RECORD COPY of ASI-015, included as
2 of 6 ASIs for reference with SPA-03

PROJECT NAME:	One River Run (Kindred) 75 Hunki Dori Ct. Keystone, CO 80435	ASI #:	015	<input checked="" type="checkbox"/> OWNER <input checked="" type="checkbox"/> ARCHITECT <input type="checkbox"/> CONSULTANT <input checked="" type="checkbox"/> CONTRACTOR <input type="checkbox"/> FIELD
PROJECT #:	117033	DATE OF ISSUANCE:	04/12/24	
OWNER:	One River Run Acquisition Keystone Investments, LLC 132 West Main Street, Suite D Aspen, CO 81611	ARCHITECT:	OZ Architecture, Inc.	
		TO CONTRACTOR:	PCL Construction Services, Inc	
		CONTRACT FOR:	GMP/Building Permit Resubmittal	
		CONTRACT DATED:	September 23, 2021

DESCRIPTION: This ASI provides updated Architectural, Structural and MEP drawings to change three (3) sets of storefront swing doors to sliding doors. This change in scope is being made at the request of the future operator, Vail Resorts, and is being incorporated into the current construction by PCL because these three (3) sets of doors are part of the building core and shell. The change affects doors 067A, 050A, and 050C which serve the Area B Retail and Area D Retail 050 spaces, located within the Type I Con

SCALE: 1/8" = 1'-0"
SHEET NUMBER
M-300D

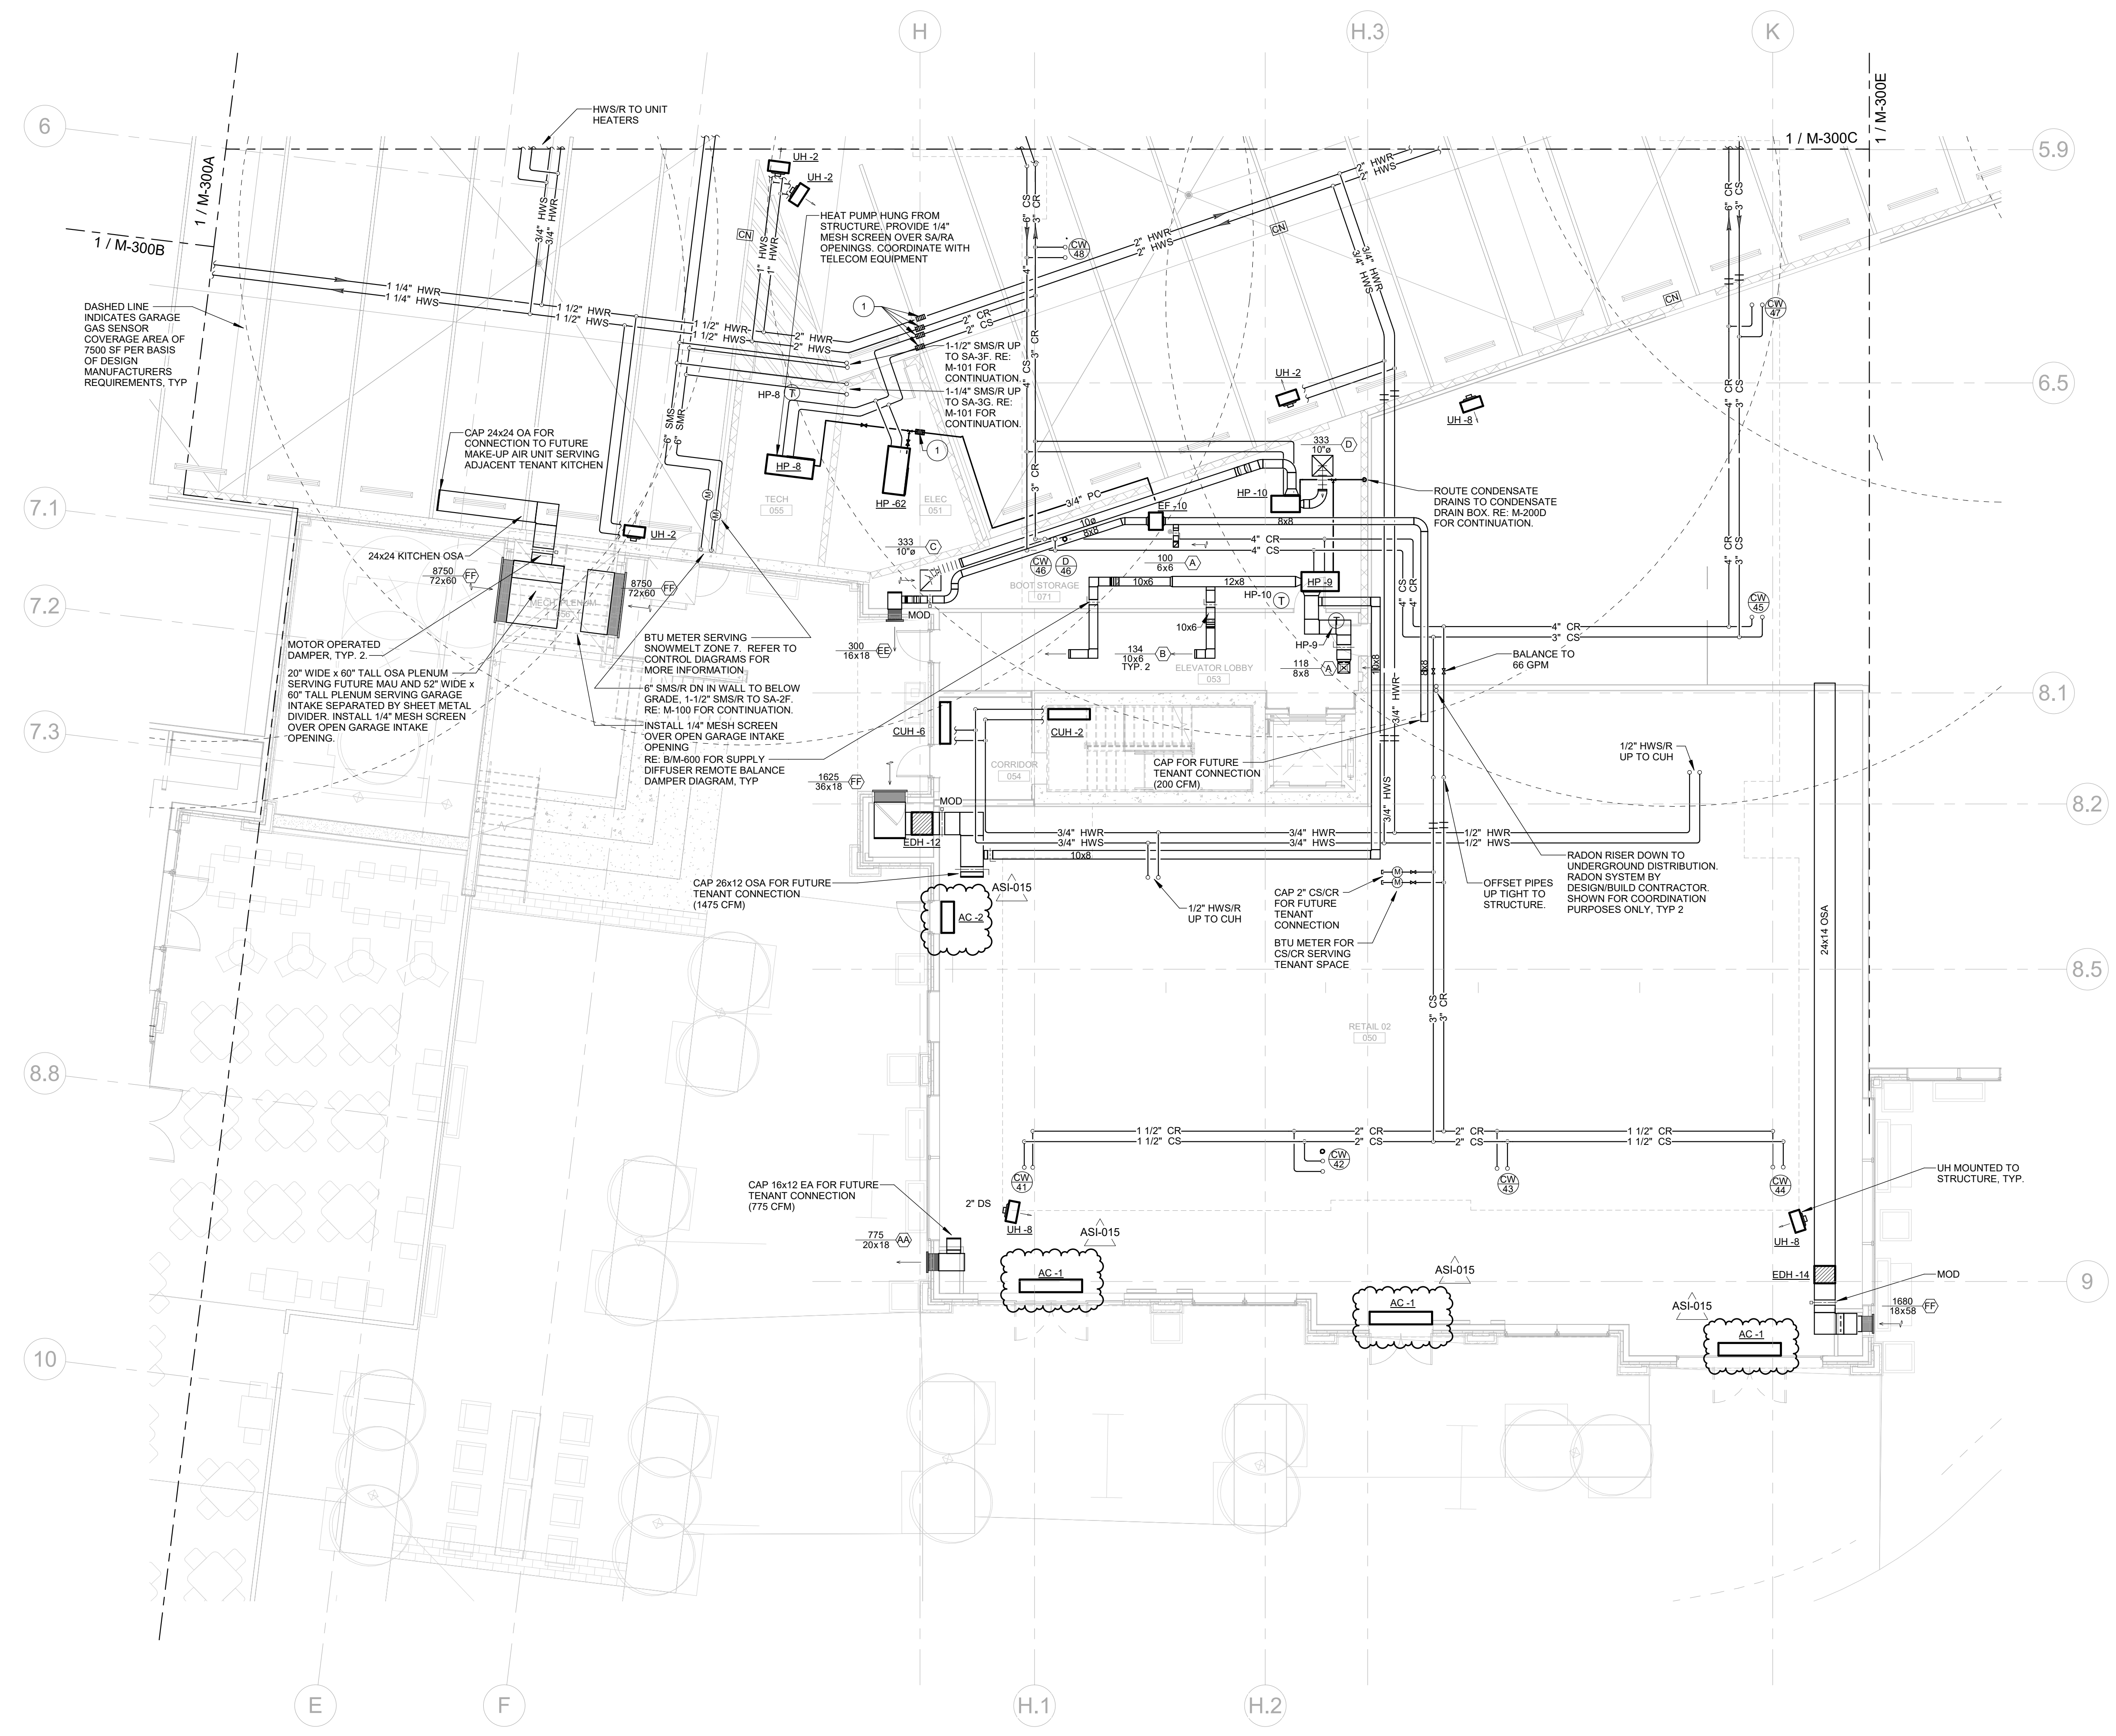
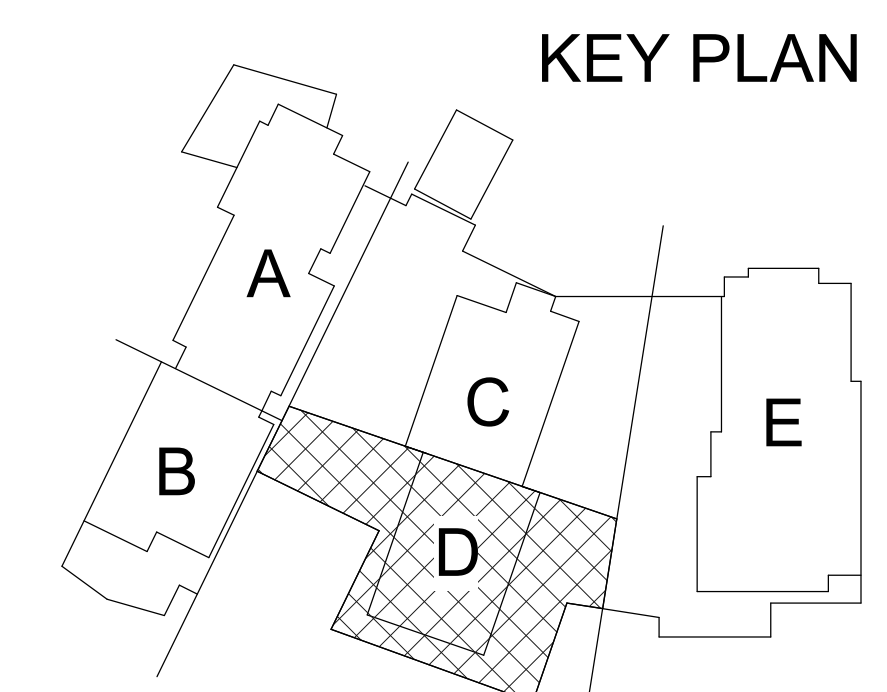
- **Mechanical Drawings**
 - **Sheet M-003, MECHANICAL SCHEDULES**
Added air curtain schedule and AC-1 and AC-2.
 - **Sheet M-300D,**
Added four (4) air curtains at the doors of the retail area.

SCALE: 1/8" = 1'-0"
SHEET NUMBER
E-200B

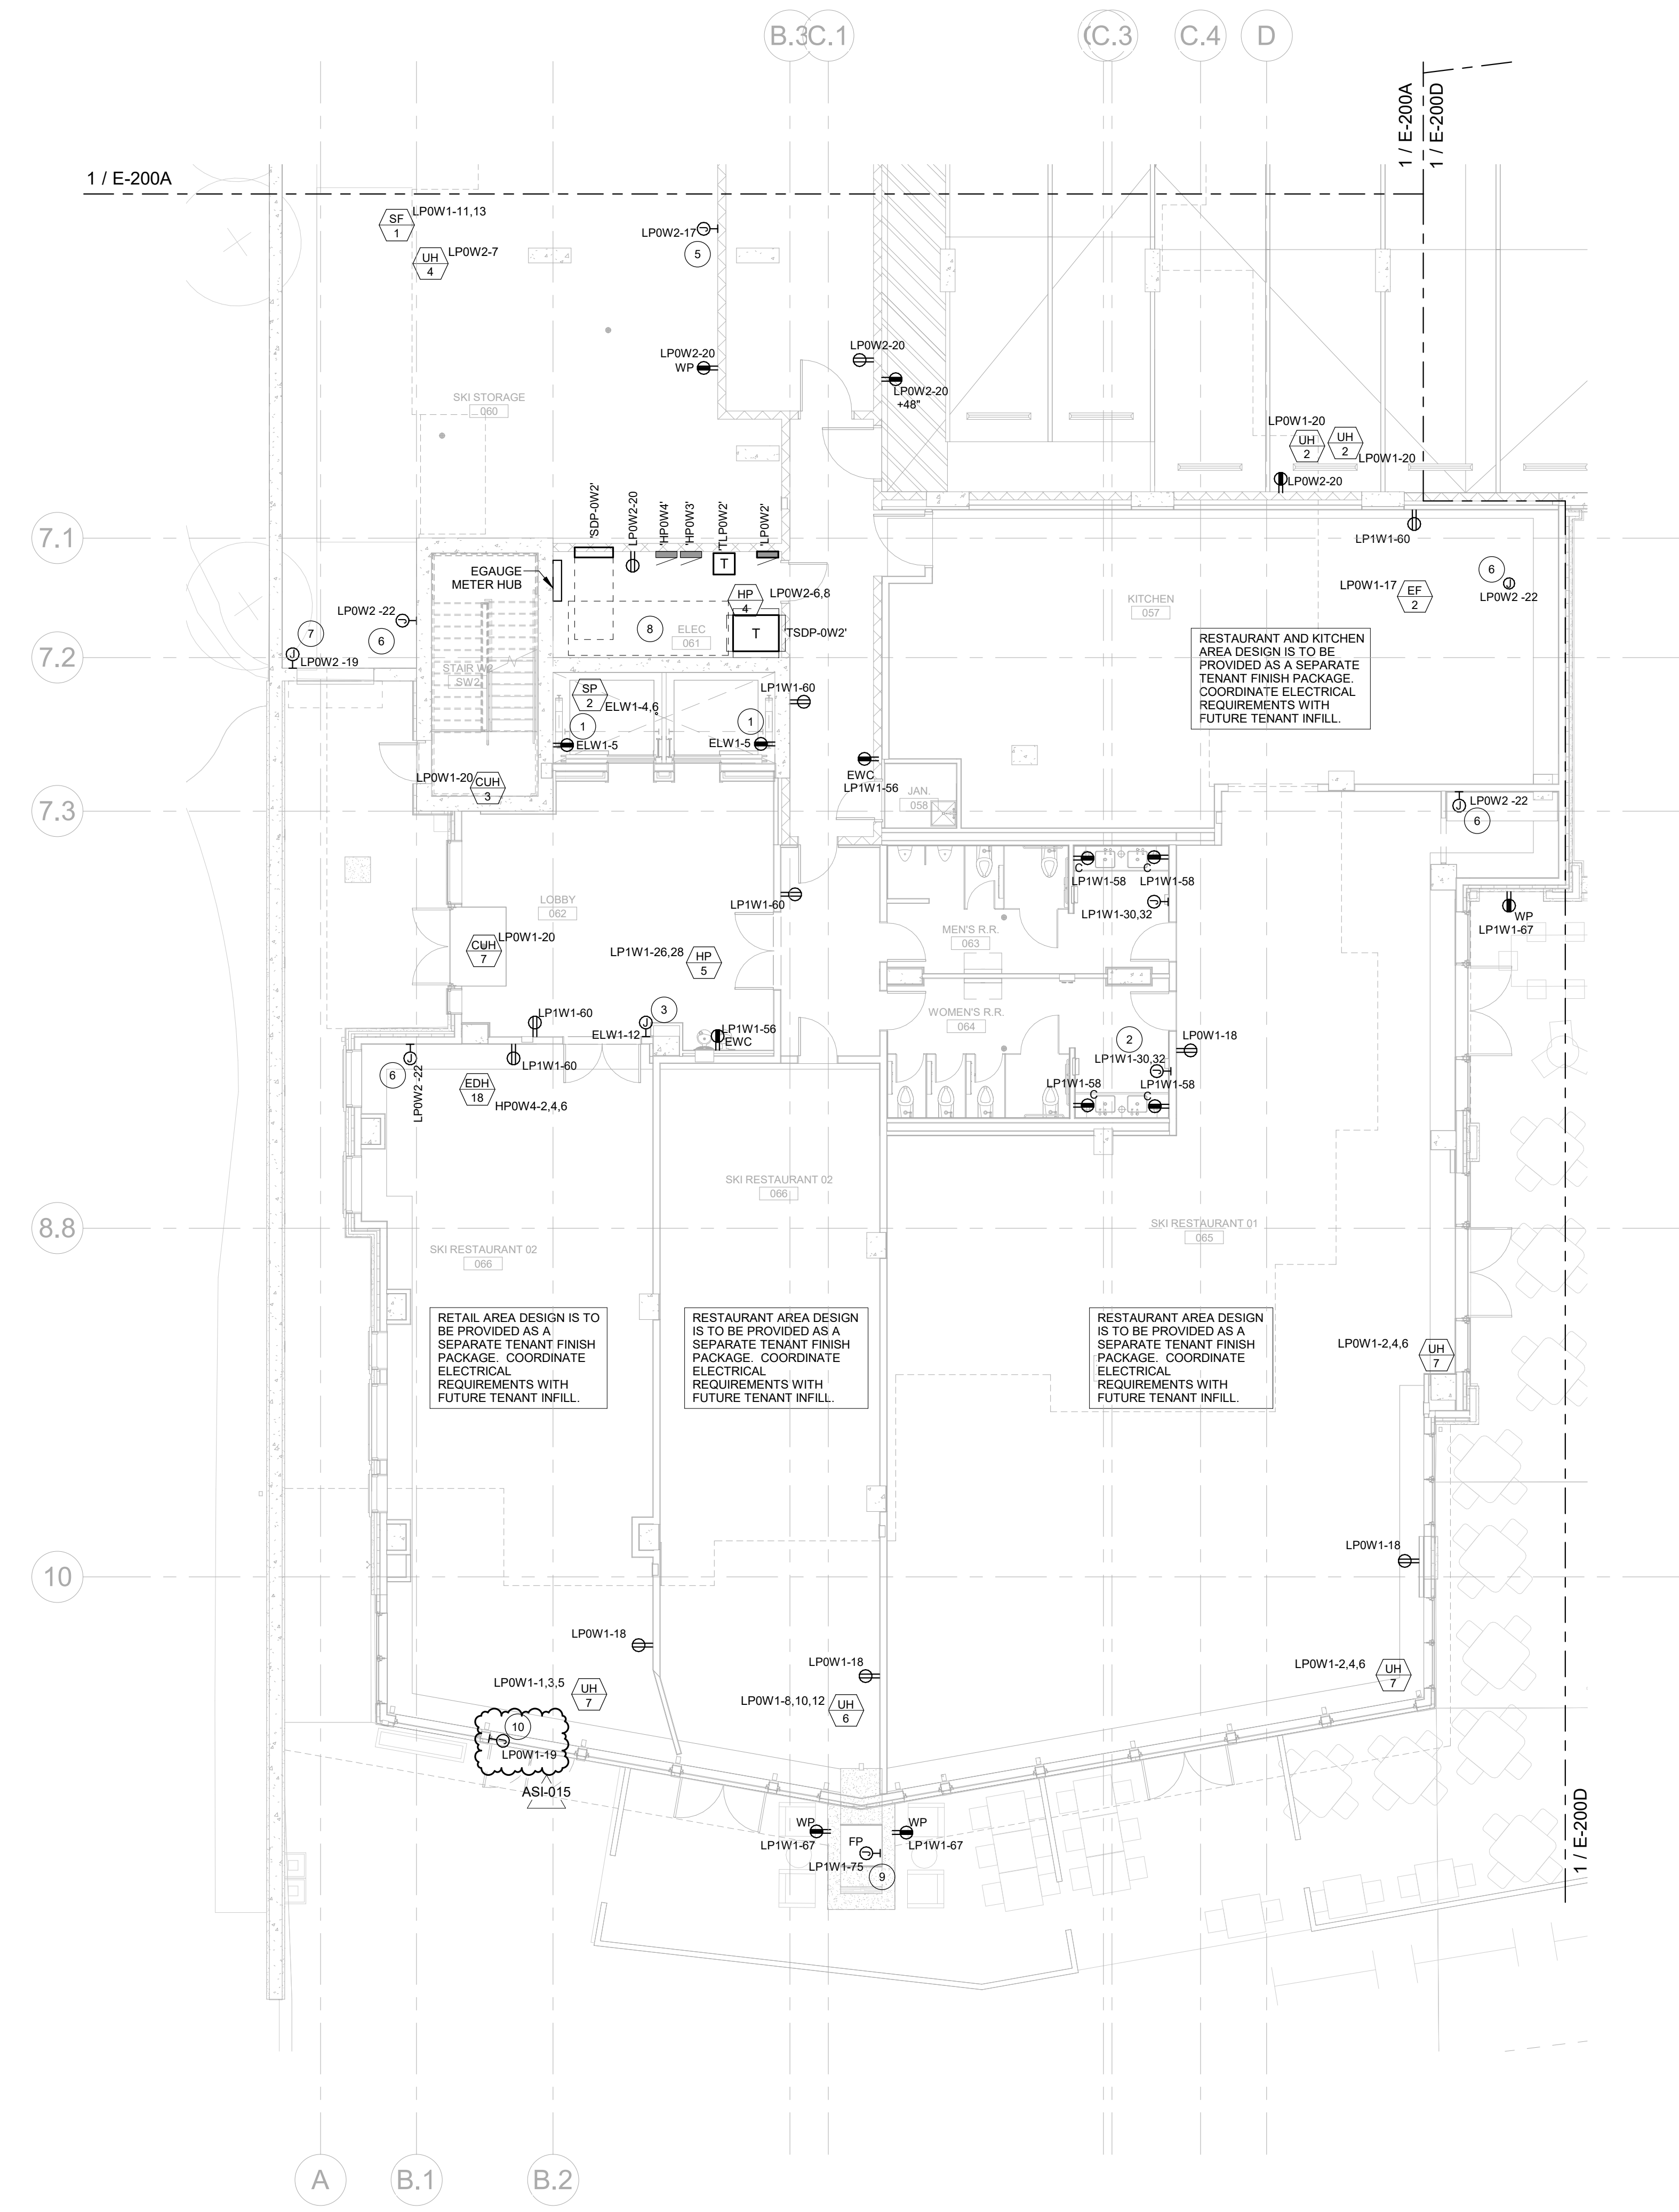
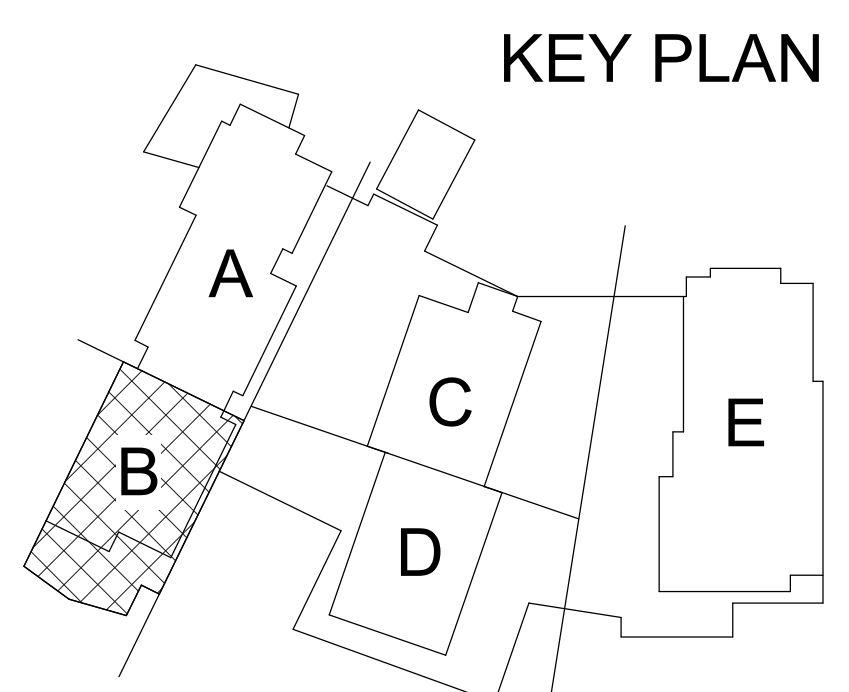
- **Sheet E-200B, GARAGE LEVEL ELECTRICAL PLAN - AREA B**
Added motorized door per Vail Resorts request.

- 10 PROVIDE JUNCTION BOX AND 120V, 20A CIRCUIT FOR MOTORIZED DOOR. COORDINATE EXACT LOCATION AND INSTALLATION REQUIREMENTS WITH ARCHITECT AND APPROVED SHOP DRAWINGS PRIOR TO ROUGH-IN.

E-200D

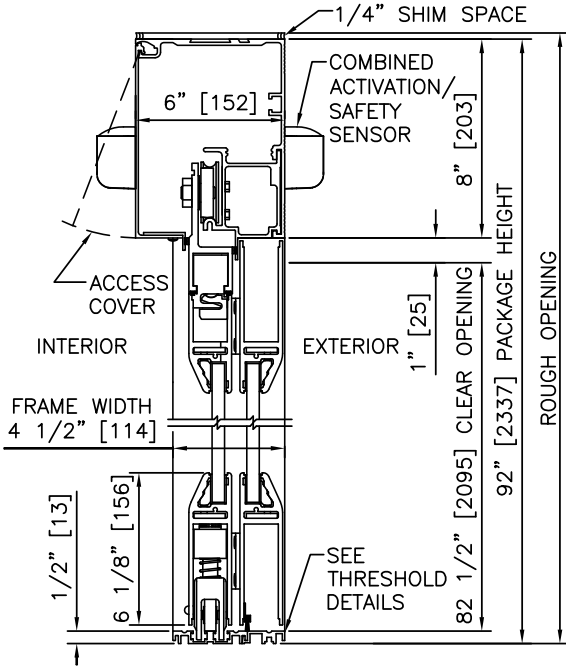
- **Sheet E-200D, GARAGE LEVEL ELECTRICAL PLAN - AREA D**
Added motorized doors and air curtains per Vail Resorts request, as well as panel HPOC3 to feed air curtains.

- 7 PROVIDE RECEPTACLE IN ELEVATOR PIT.
- 8 PROVIDE JUNCTION BOX AND 120V, 20A CIRCUIT FOR MOTORIZED DOOR. COORDINATE EXACT LOCATION AND INSTALLATION REQUIREMENTS WITH ARCHITECT AND APPROVED SHOP DRAWINGS PRIOR TO ROUGH-IN.
